UNITED STATES PATENT AND TRADEMARK OFFICE

APPLICATION NO.	FILING DATE	FIRST NAMED INVENTOR	ATTORNEY DOCKET NO.	CONFIRMATION NO.
10/619,669	07/15/2003	Partab Jeswani	DP-307786	7172

Office Action Summary

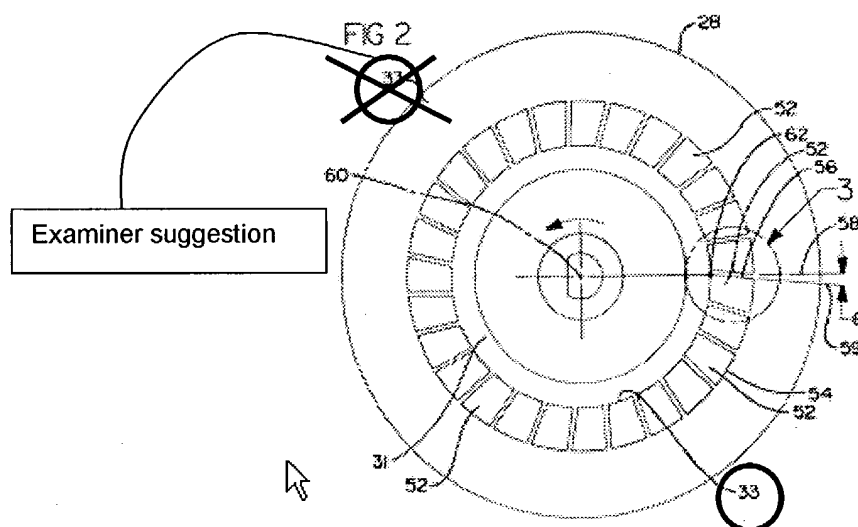
The drawings are objected to as failing to comply with 37 CFR 1.84(p)(4) because reference character "33" has been used in Figure 2 to designate both hub/inner diameter and another element (see Figure 2 reproduced below). Corrected drawing sheets in compliance with 37 CFR 1.121(d) are required in reply to the Office action to avoid abandonment of the application. Any amended replacement drawing sheet should include all of the figures appearing on the immediate prior version of the sheet, even if only one figure is being amended. The replacement sheet(s) should be labeled "Replacement Sheet" in the page header (as per 37 CFR 1.84(c)) so as not to obstruct any portion of the drawing figures. If the changes are not accepted by the examiner, the applicant will be notified and informed of any required corrective action in the next Office action. The objection to the drawings will not be held in abeyance.
